**COUNTY OF SAN MATEO
PLANNING AND BUILDING DEPARTMENT**

SUBJECT: Consideration of a Use Permit pursuant to Section 8.126.050 of San Mateo County Ordinance Code, for an existing catering kitchen and take-out restaurant, within a 2,508 square-foot commercial structure, located at 2844 Middlefield Road, in the unincorporated North Fair Oaks area of San Mateo County, to allow 1) dine-in use with indoor seating where only take-out use is currently allowed, 2) to allow parking to consist of six parking spaces where seven is allowed by zoning, 3) for the required parking to be located on an off-site, adjoining property, and 4) to allow a 6-foot high-fence where 4 feet is the limit. In conjunction with the requested permit, it is recommended that the Planning Commission determine that the project is categorically exempt from the California Environmental Quality Act (CEQA) pursuant to CEQA Guidelines Section 15301.

County File Number: PLN2024-00273 (Valdez)

PLN2024-00273: Use Permit Application for 2844 Middlefield Rd - Full Service Restaurant

SITE PLAN AND PARKING

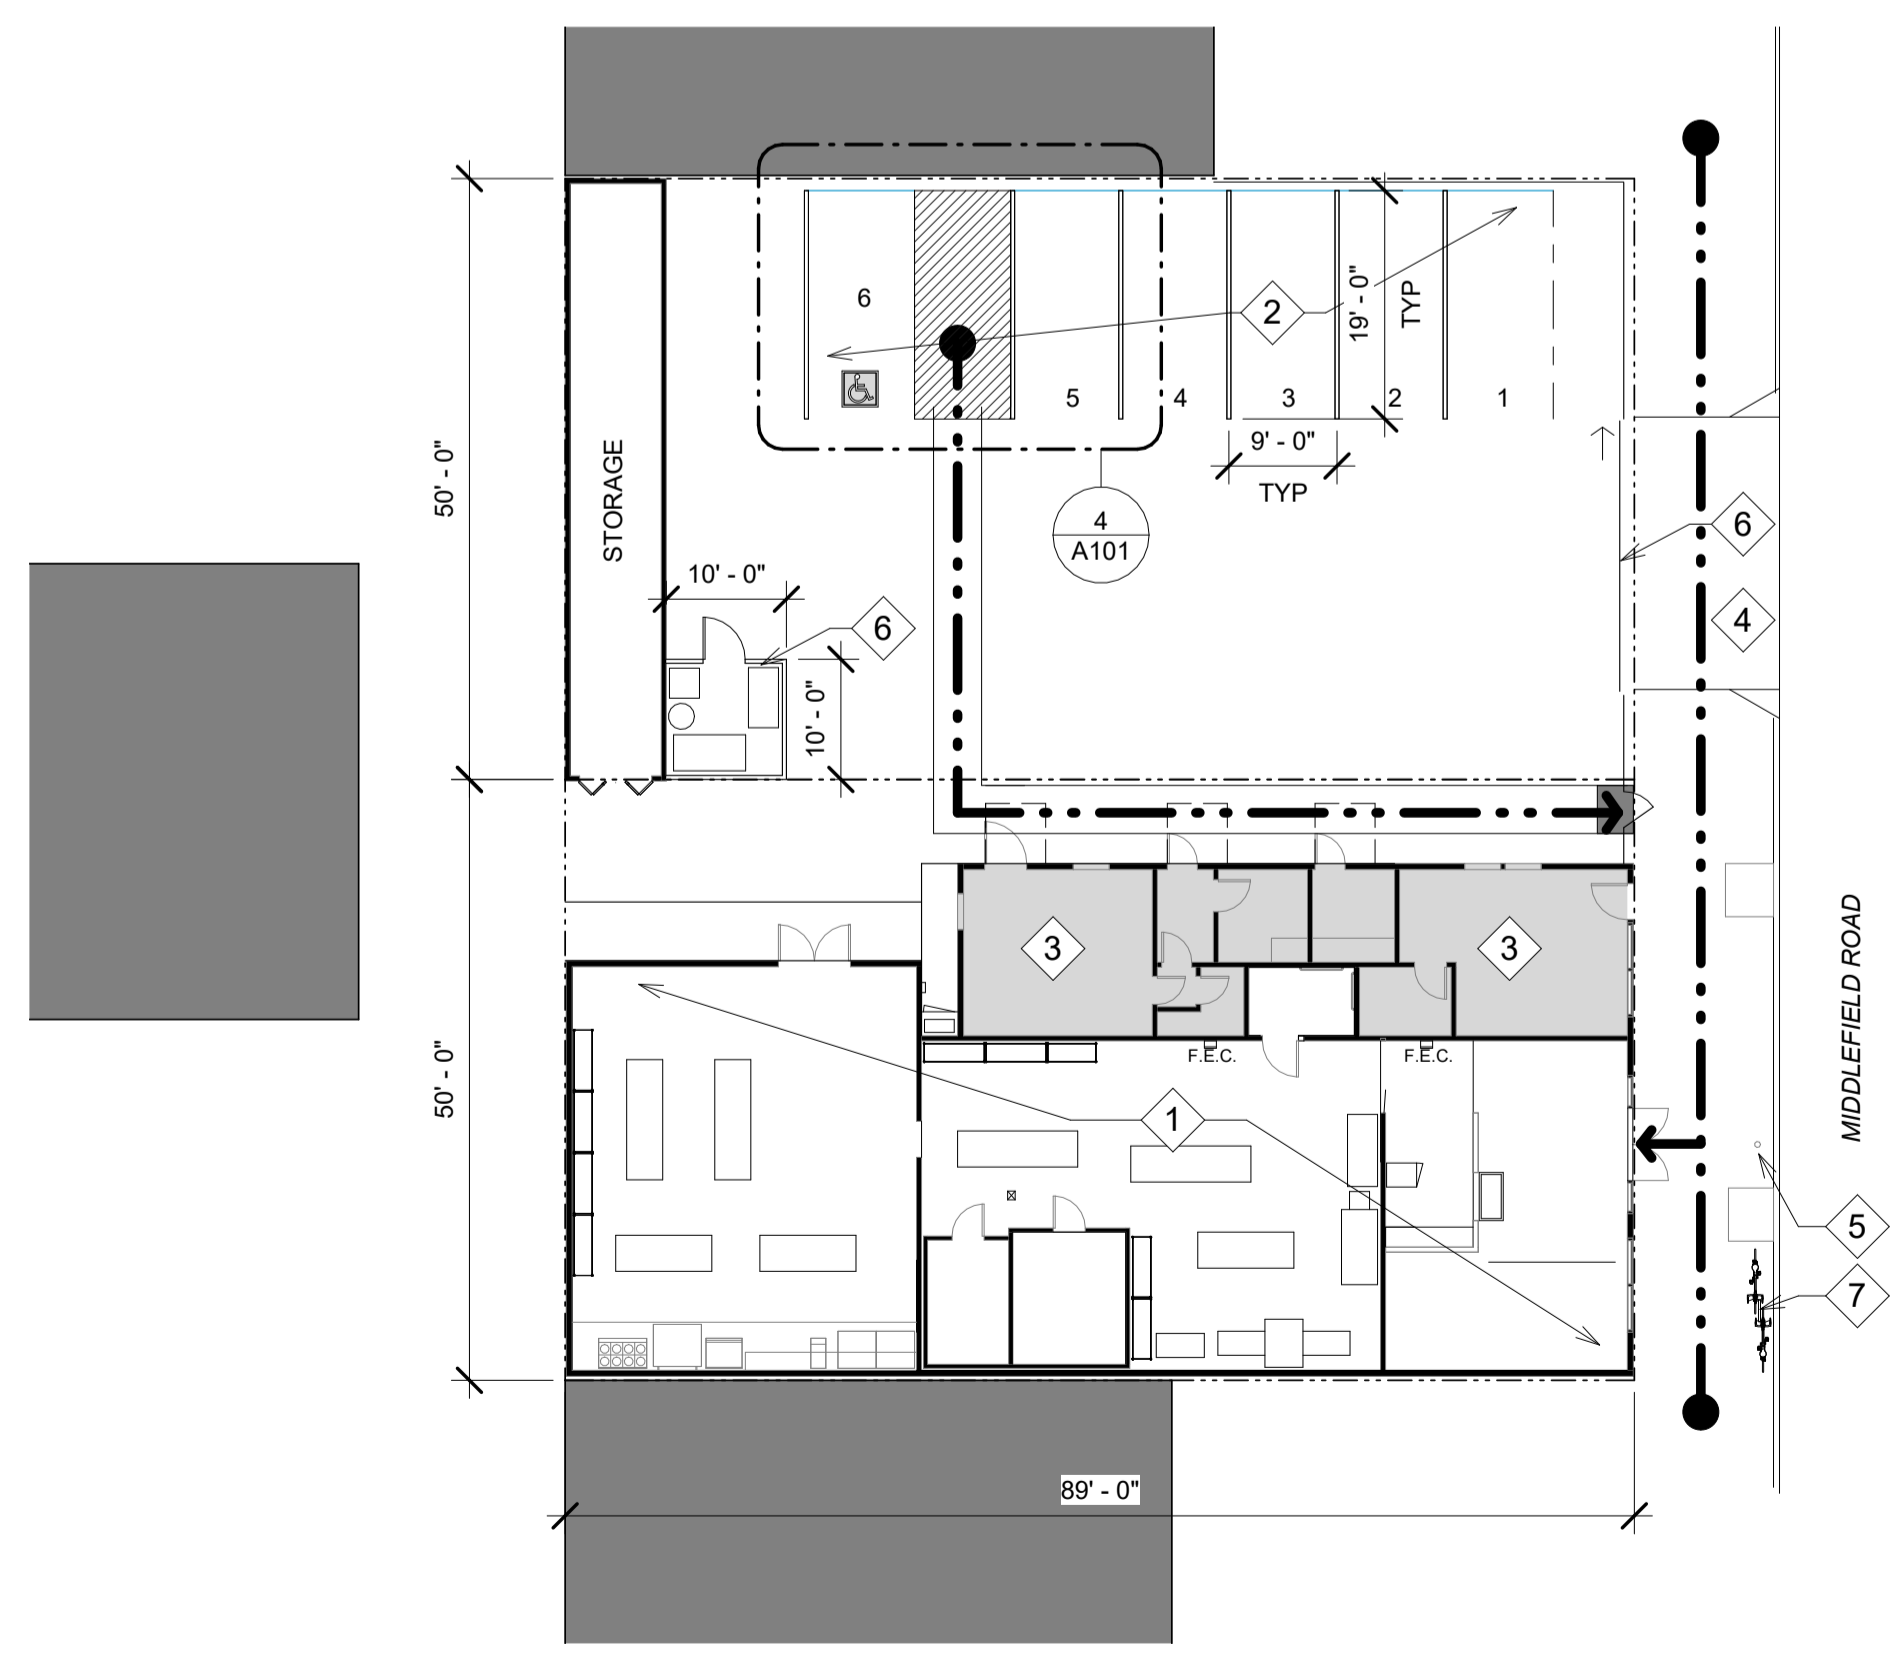
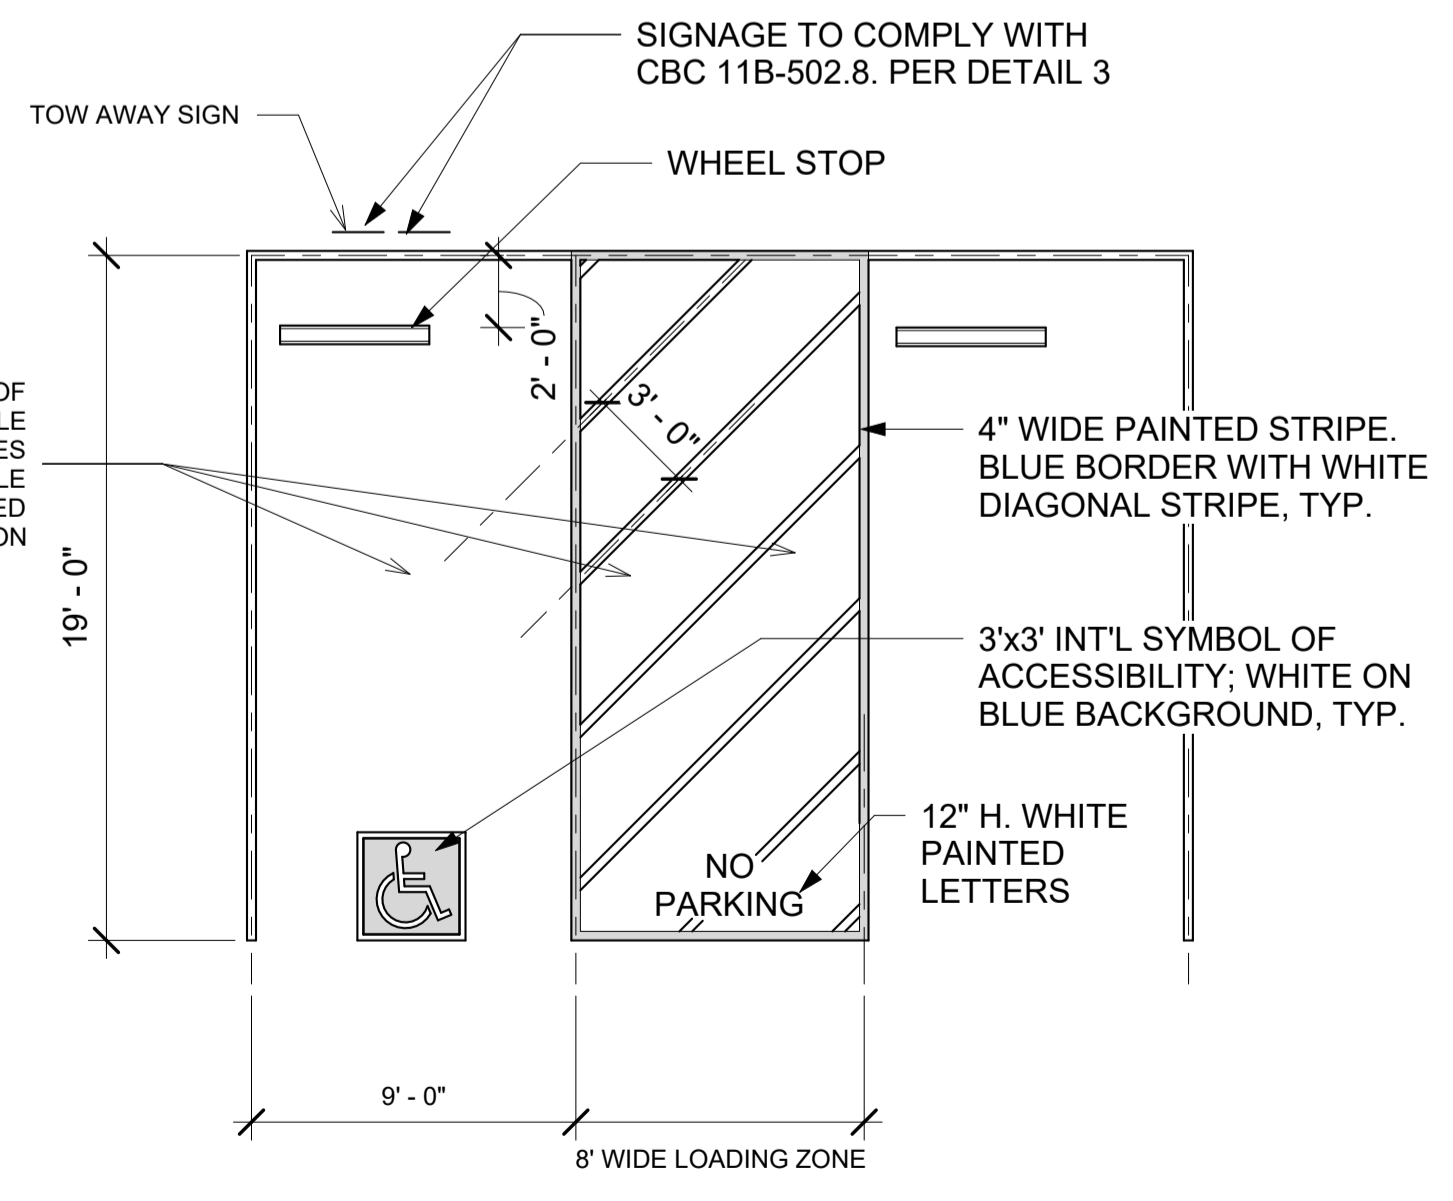
CMU3 Design Standards comments / responses

- Trash Area – Trash area located on site plan A101. 6’ high opaque fence will be built on three sides of this enclosure per the plan and image on this sheet

- Bicycle Racks – One short term bike parking space is required / provided at the front of the restaurant per San Mateo County Municipal Code section 27.64.262, shown on A101

- Existing Fence – The existing approx. 5’ high steel picket security fence at the parking lot is proposed to remain in place for multiple reasons. Photo of existing gate added to A101 for reference. Below are reasons why El Sur should be allowed to keep the gate:

- After hours security – without this fence, cars will park in the lot after hours. Nearby night clubs also attract late-night crime and vandalism, so the existing gate helps deter that element from the parking lot, so we request to leave it in place. A 4’ high fence as noted on the CMU3 guidelines would not be sufficient to deter loitering and vandalism. During daytime hours, the gate is open for customer parking.

- This is an existing condition, that was inherited by El Sur – it should be allowed to remain as an existing/non-conforming element.
 - The existing gate is a see-through steel picket gate, not chain link, so it is in line with the CMU3 design guidelines which specifically disallows chain link. If you look at practically every other parking lot in this vicinity, you will see chain link. Full compliance with this CMU3 regulation would be unfair to El Sur. This is a picture directly across the street for example where you will see chain link with vinyl inserts on the property line:

Parking spaces have been numbered and dimensioned on the site plan A101

EXTERIOR ELEVATION

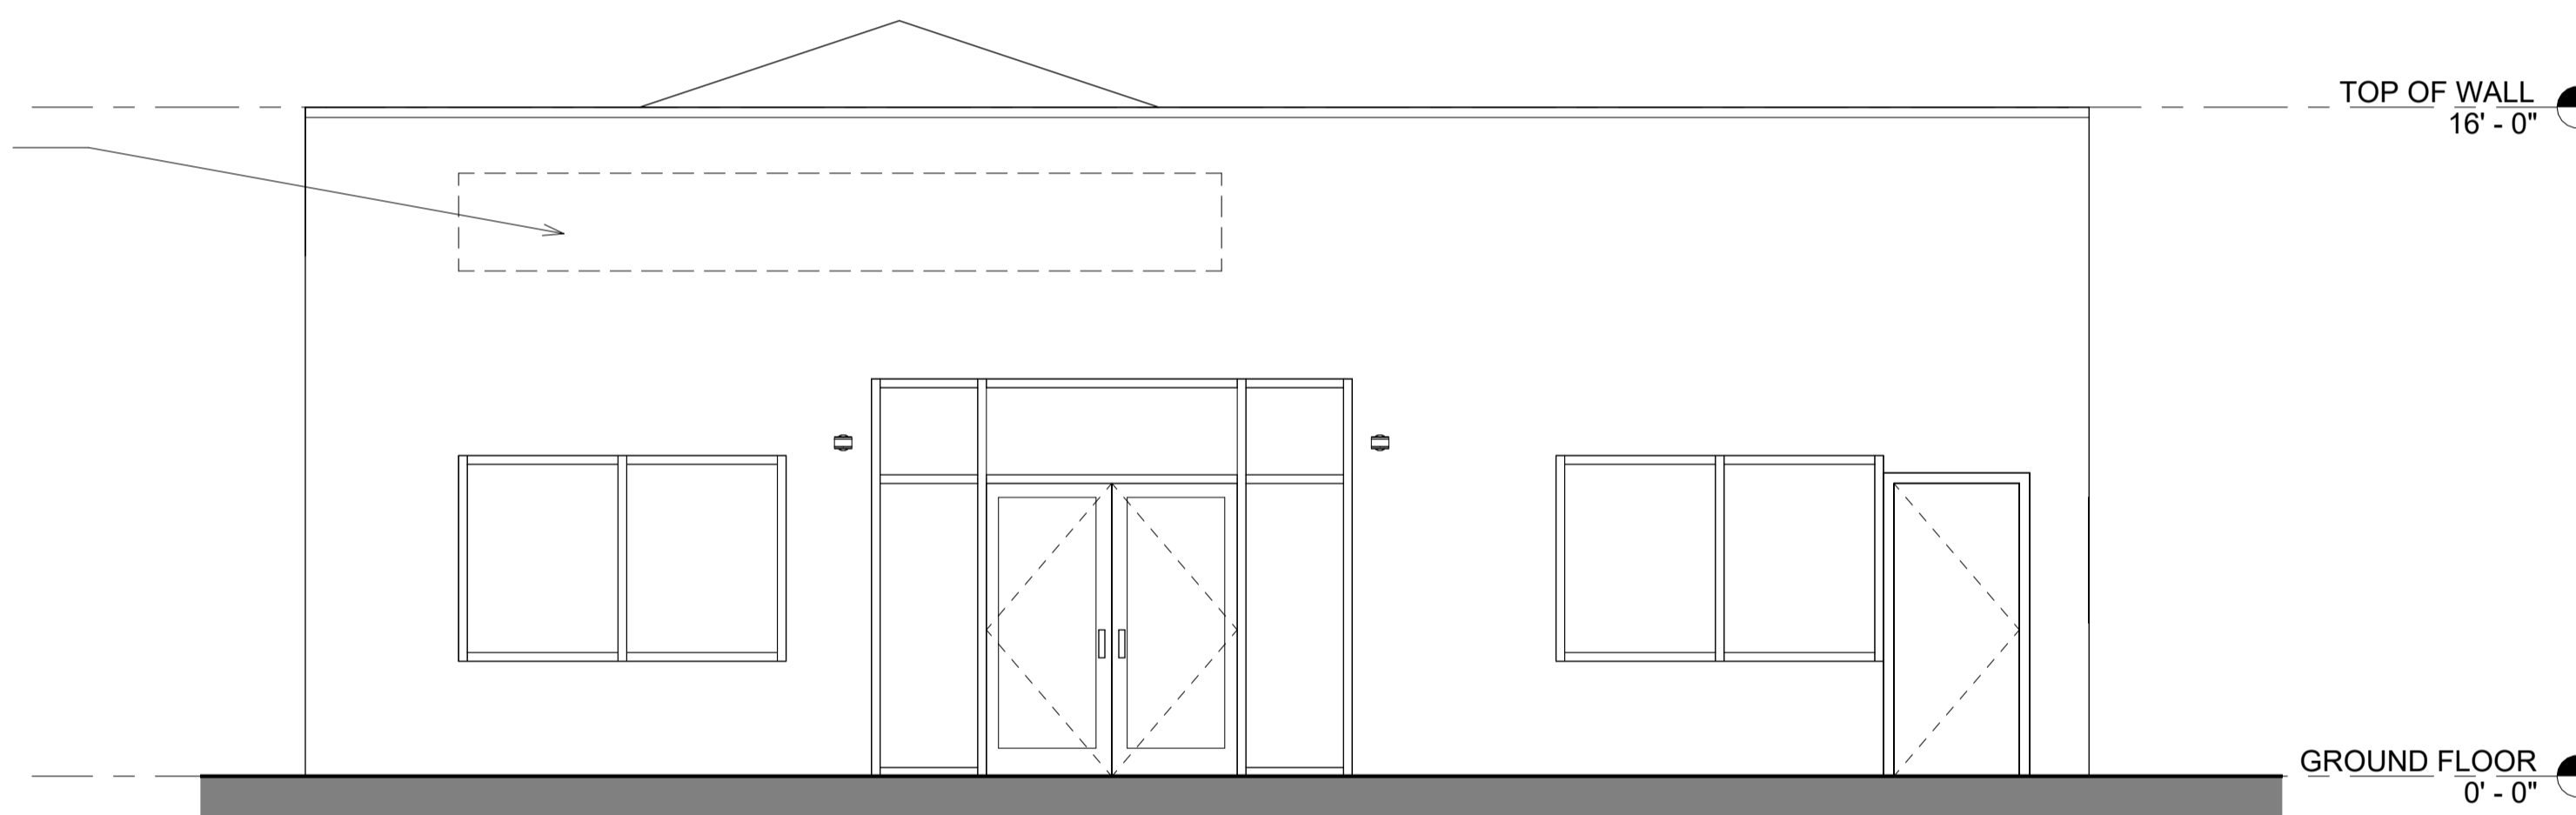
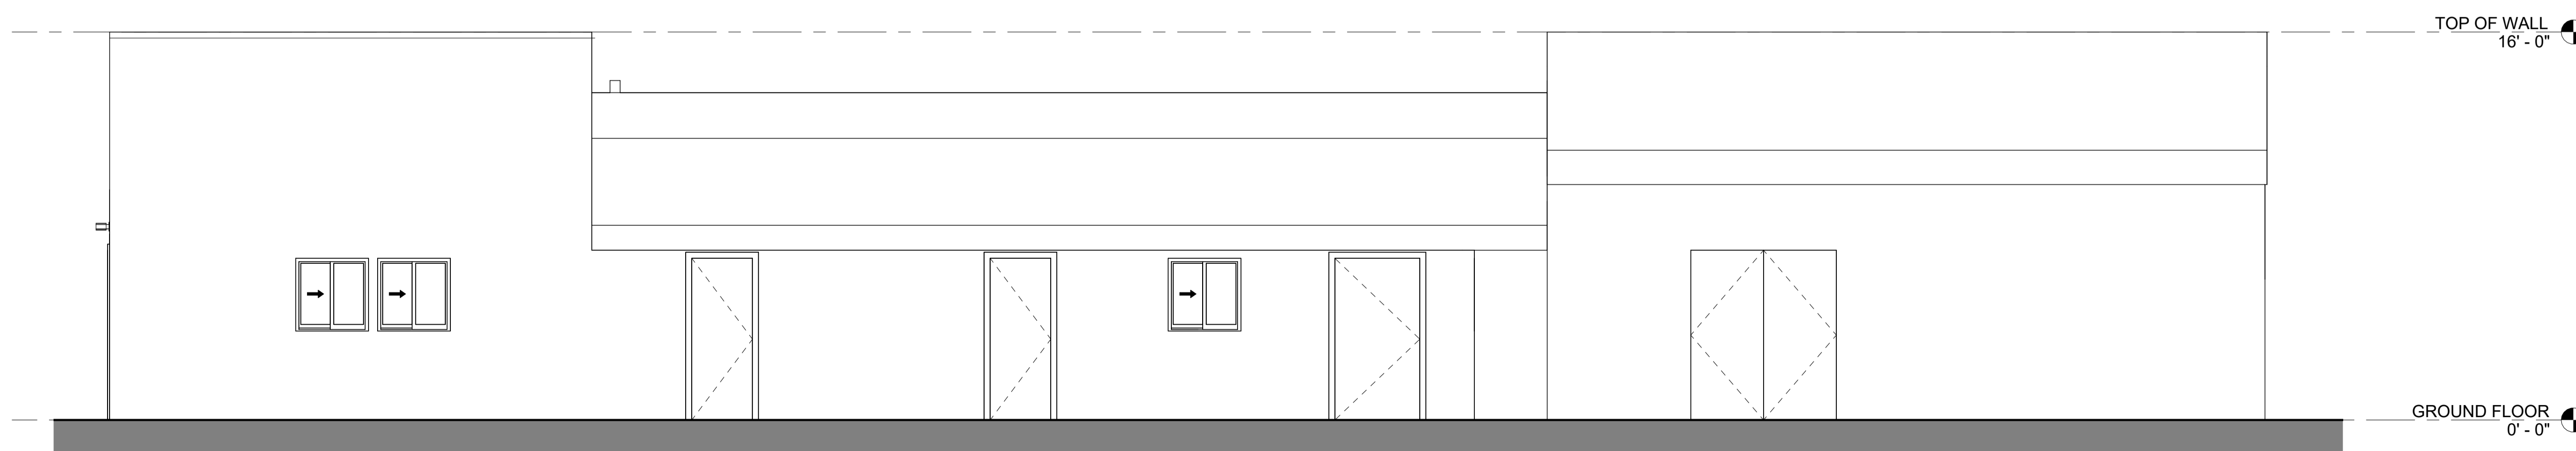
Signage

Existing photo of the painted signage has been added to the drawings on sheet A301
